Item: 145kV CT

Ratio: 300-200/1-1-1A (3 C)

Customer: APTransco, Andhra Pradesh

List of Standard Drawings/Documents:

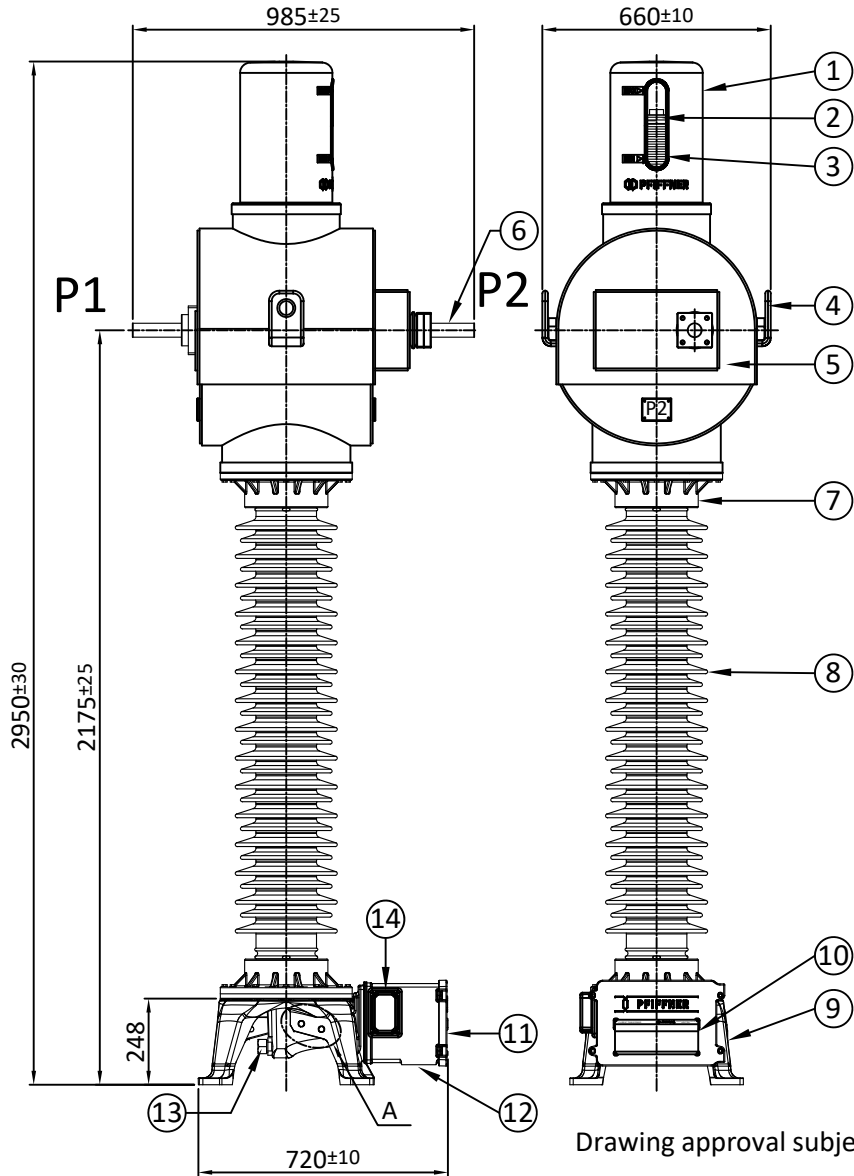
Variation of Tan Delta Value from 10KV $\mu\text{m}/\sqrt{3}$ shall be not exceed 15%.

1. Minimum 300mm plinth shall be maintained for CT/PT/CVT/ Isolators/IVT in the substation during foundation works to ensure safe live to ground clearance as per IE rules.
2. Since the supply of terminal connectors is not in the scope of manufacturers as mentioned in the drawings. The EPC contractors shall be instructed to supply the same in line with CT/PT/CVT/Isolator /IVTs requirement and capatibility.

NOTE:-1. Drawings approval subject to valid type test reports, to be checked during acceptance tests.
2. For EPC contractors only.

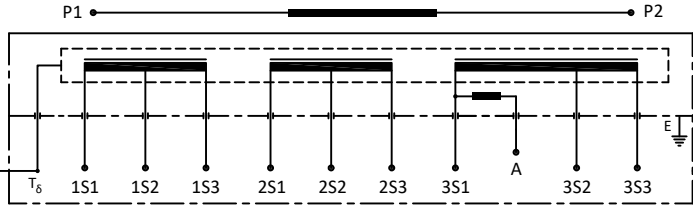
Variation of Tan Delta Value from 10KV um/sqrt 3 shall be not exceed 15%.

1. Minimum 300mm plinth shall be maintained for CT/PT/CVT/ Isolators/IVT in the substation during foundation works to ensure safe live to ground clearance as per IE rules.

2. Since the supply of terminal connectors is not in the scope of manufacturers as mentioned in the drawings. The EPC contractors shall be instructed to supply the same in line with CT/PT/CVT/Isolator /IVTs requirement and capatibility.

NOTE:-1. Drawings approval subject to valid type test reports, to be checked during acceptance tests.

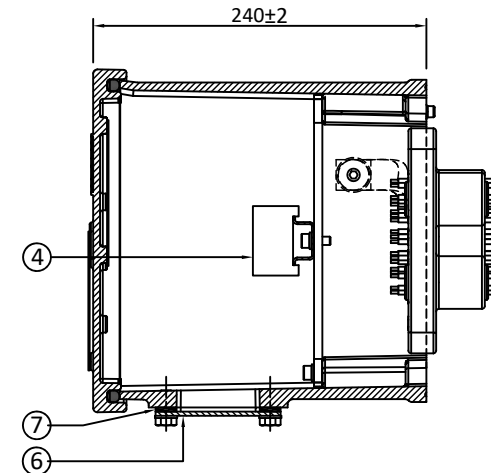
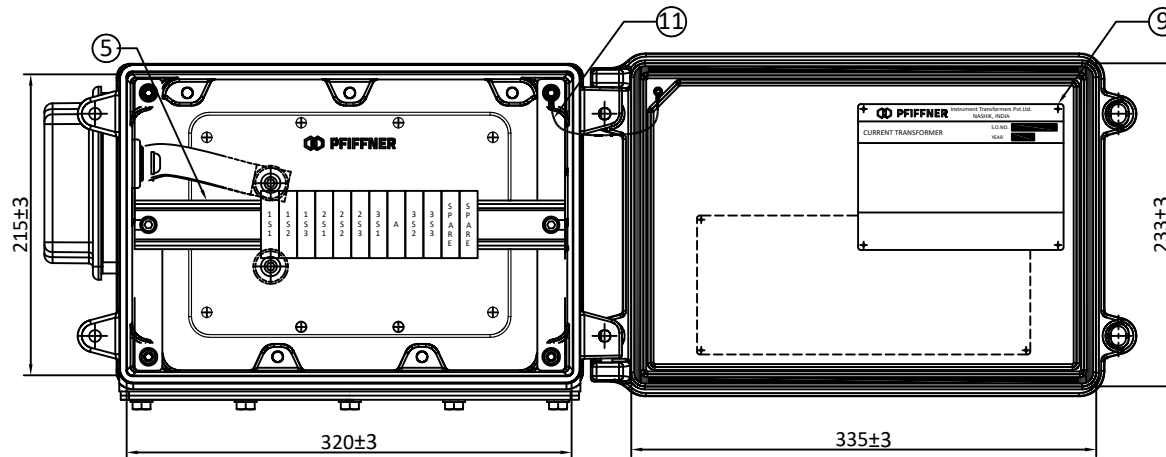
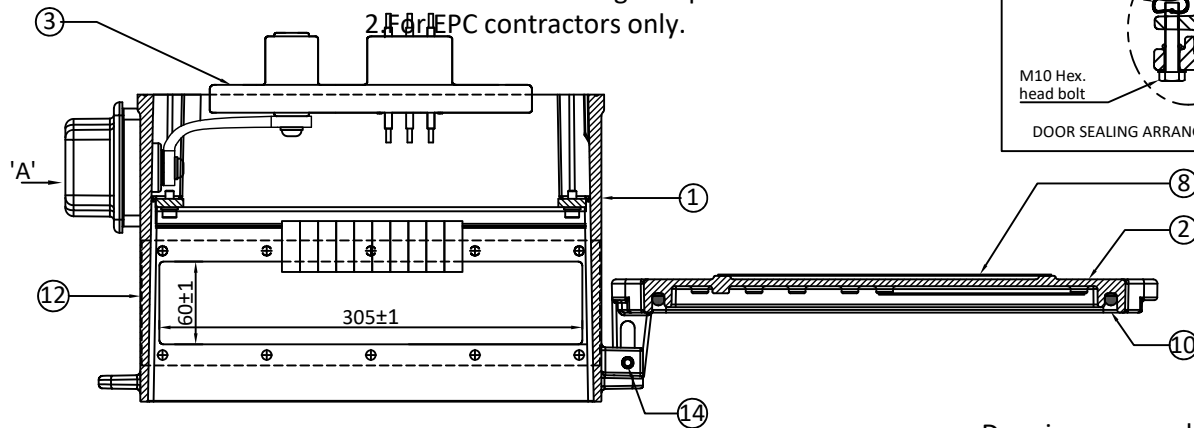
Variation of Tan Delta Value from 10KV um/sqrt 3 shall be not exceed 15%.

NOTE:-1. Drawings approval subject to valid type test reports, to be checked during acceptance tests.
2. For EPC contractors only.

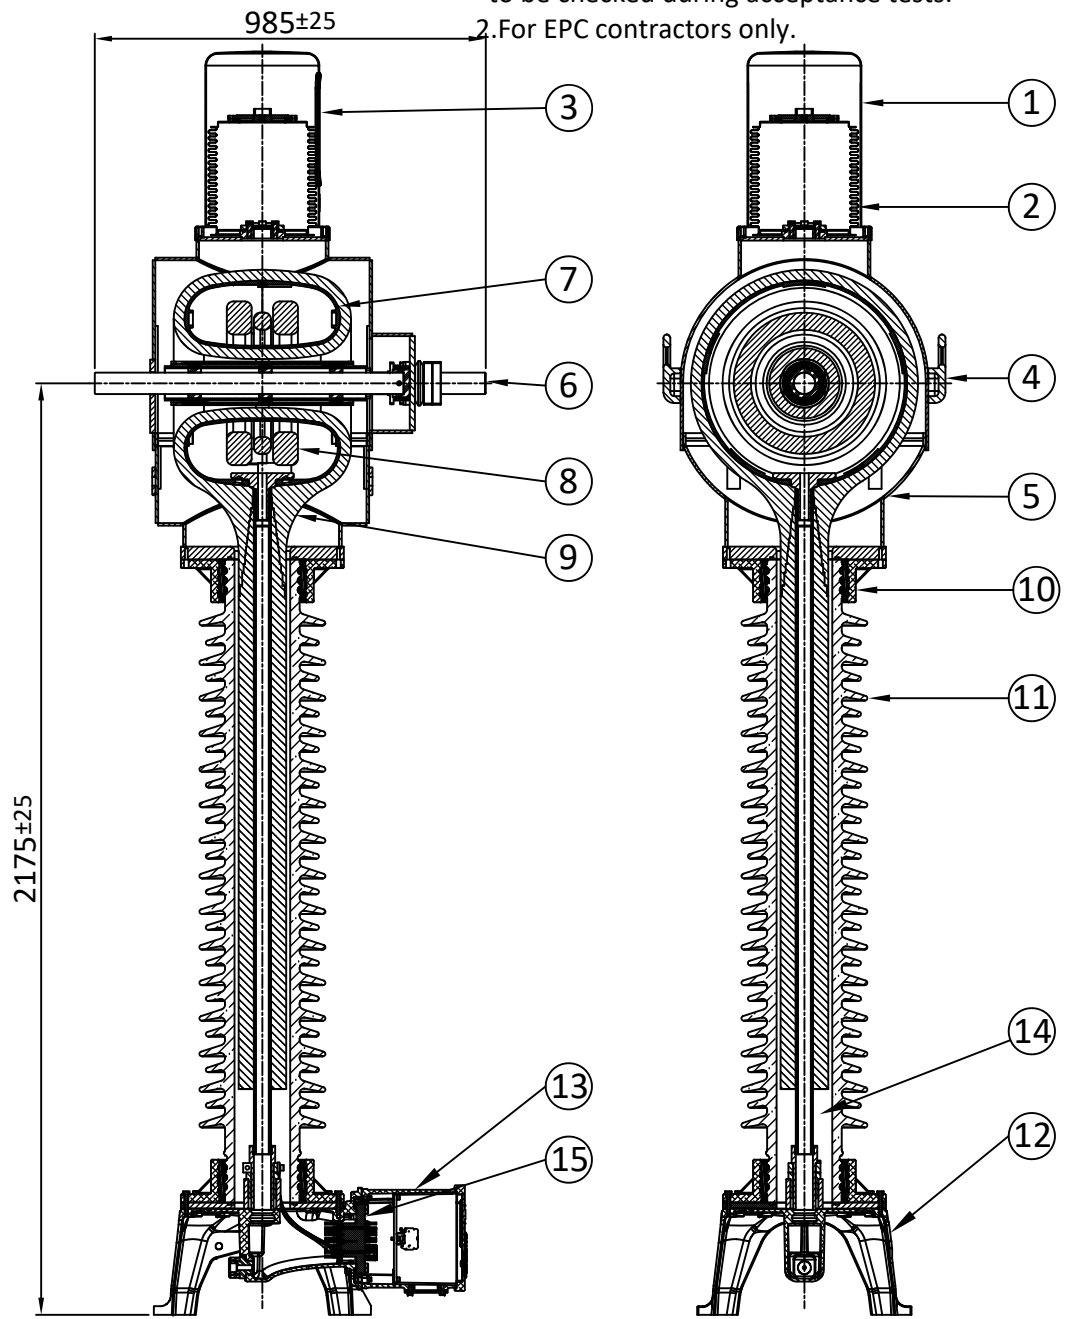
Variation of Tan Delta Value from 10KV um/sqrt 3 shall be not exceed 15%.
